- SUBJECT:
1. Environmental Determination
  2. Tentative Map (APN: 119-220-57) (P85-083)
  3. Subdivision Modification to defer Parkland Dedication Obligation for the Remainder Parcel

LOCATION: South side of Brookfield Drive, 1400+ feet west of Franklin Boulevard

**TENTATIVE MAP**  
**BROOKFIELD MEADOW NO. 2**  
CITY OF SACRAMENTO, CALIFORNIA  
JANUARY, 1985

APPLC. NO. P85-083

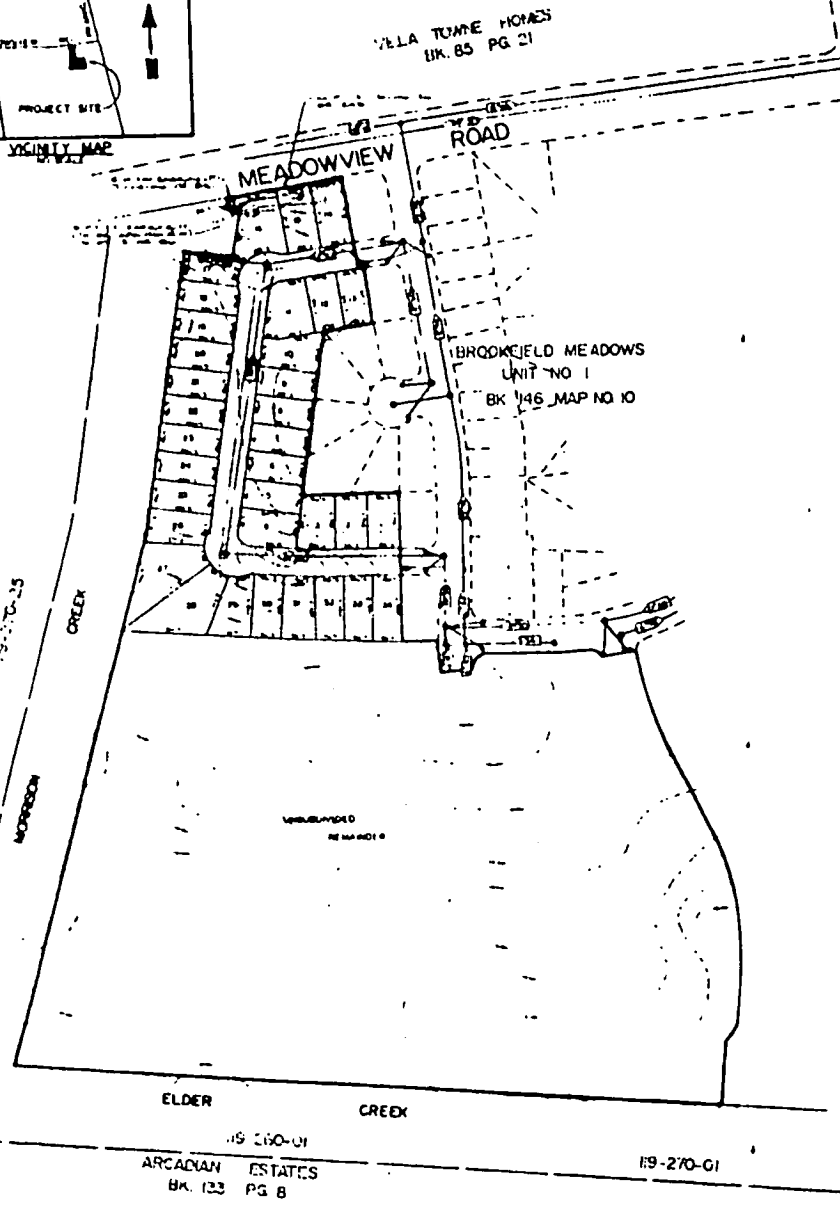
8. Prepare a right-of-way study for the existing canal. Possible slope easement dedication required;
9. Construct a chainlink fence along the canal right-of-way;

10. Provide a drainage easement through Lot 17. May require redesign of existing drain line relocation;
11. Place the following note on the final map: "Parkland dedication requirements for the remainder parcel must be met upon issuance of any building permits, or approval of further subdivision requests."

FENCE DETAIL

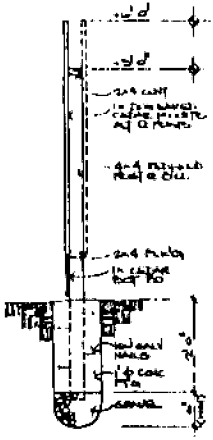
This is consistent with the existing development in Phase I. However, the fenced court design is not consistent with the criteria developed by staff and the Commission within the last two years which basically requires unit orientation along the public streets for neighborhood security purposes. The six-foot high wooden fence around the front court area blocks the view from within the dwelling to the street area. Staff therefore suggests the front court fence be eliminated or redesigned to allow an open area for visual contact between the window and the street. Such a redesign could consist of a four-foot high solid wooden fence or a four-foot high solid wooden fence with a two-foot high open trellis (vertical 2" x 2"). This redesign would also provide a contrast and blend with the existing structures.

4. A variety of one and two-story units shall be utilized;
5. The front court fence shall be eliminated or redesigned as indicated in the Staff Evaluation. The redesign shall be reviewed and approved by the Planning Director prior to issuance of buiding permits.
